The Assessment Manager
Brisbane City Council
By Email

Submission – Change Application for 99 Thorn Street, Kangaroo Point
Council Reference: A007013156

Figure 1 - BCC City Plan Setback and separation requirements

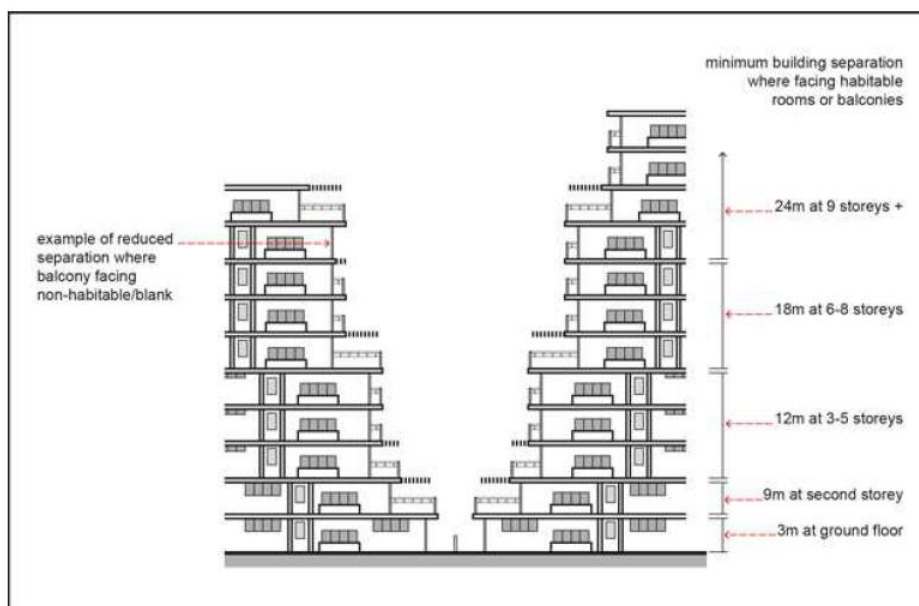
Table 9.3.14.3.F prescribes progressively increasing separation distances according to building height, requiring up to 24 metres where buildings exceed nine storeys and contain habitable rooms or balconies. The figure below is an extract from the Multiple dwelling code which depicts the building separation requirements.

Instead, it appears the applicant seeks to rely upon the generous setbacks already provided by in order to justify reduced separation on its own site. That approach is fundamentally inconsistent with the intent of the City Plan.

The purpose of the building separation provisions is to ensure that each development independently contributes to achieving acceptable separation outcomes. Those provisions are directed towards maintaining privacy, outlook, daylight, ventilation and an appropriate sense of openness between buildings.

Overall Outcome 9.3.14.2(2)(q) reinforces that objective by requiring development to appropriately manage its interface with adjoining residential uses through sufficient building separation to protect visual privacy and residential amenity. Those considerations are particularly important in this instance because the proposed development contains numerous balconies directly facing adjoining residential properties.

By effectively appropriating the generous separation currently provided by the proposal transfers the burden of compliance onto adjoining landowners. Should be redeveloped in the future, the proposed development would constrain the form of that redevelopment or alternatively compel future buildings to be positioned substantially closer to the common boundary than contemplated by the City Plan. This loss of development right as a result of the development approval at 99 Thorn would ordinarily give rise for compensation, reserves its rights in that regard. That is precisely the outcome which the building separation provisions seek to avoid. Such outcomes are to be clearly avoided under the Multi-dwelling Code Performance Outcomes PO3, PO6 and PO14 which cannot be met by the current proposal or the former approval.
